PROJECT TITLE: Prairie Song Reliability Project (PSRP)

DOCKET: 25-OPT-02

SUBJECT: PSRP (25-OPT-02) Crotch's Bumble Bee Spring 2026 Survey Results

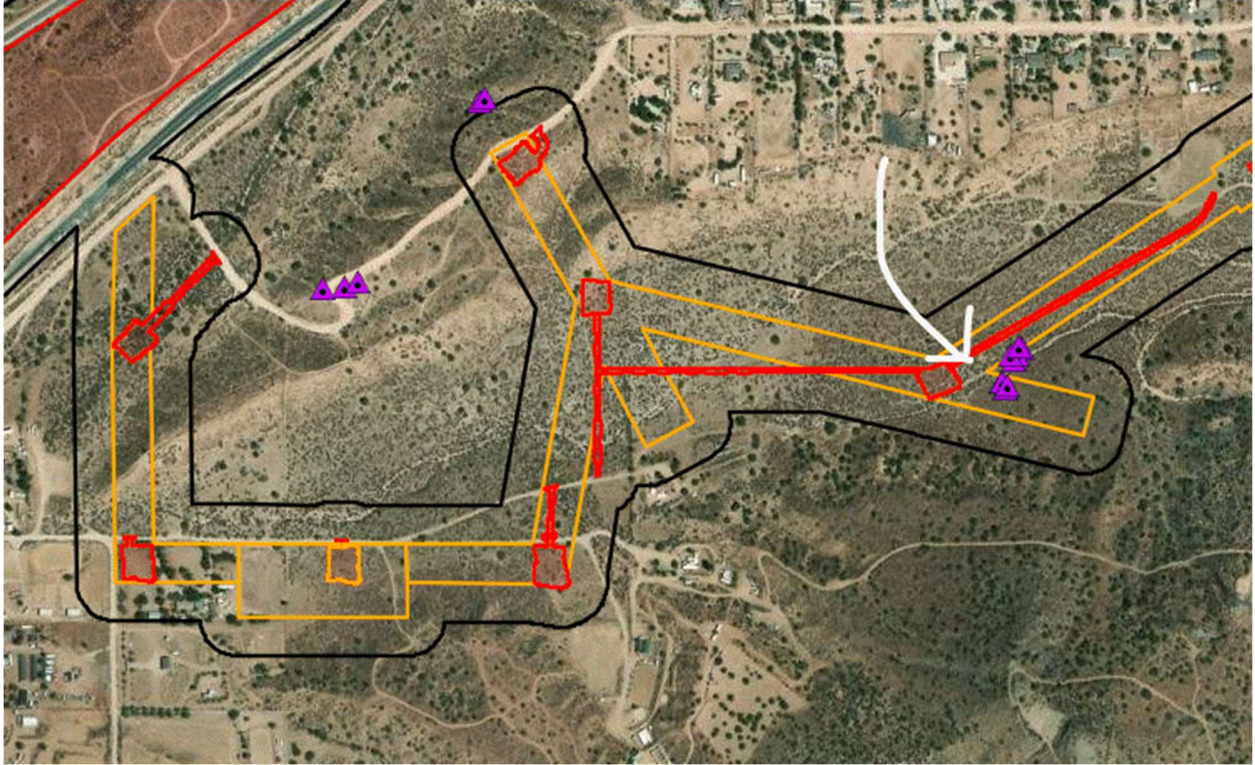
On Friday May 8, we observed two Crotch's bumble bees foraging on Phacelia distans. Many common bumble bee individuals (*Bombus vosnesenskii* and *Bombus vandykei*) were also observed. Floral resources are senescing throughout the site. The final survey pass is currently scheduled for May 22. The purple triangles below show the location of CBB observed to date. The white arrow is the location of the two observed this past Friday. Let us know if any questions.
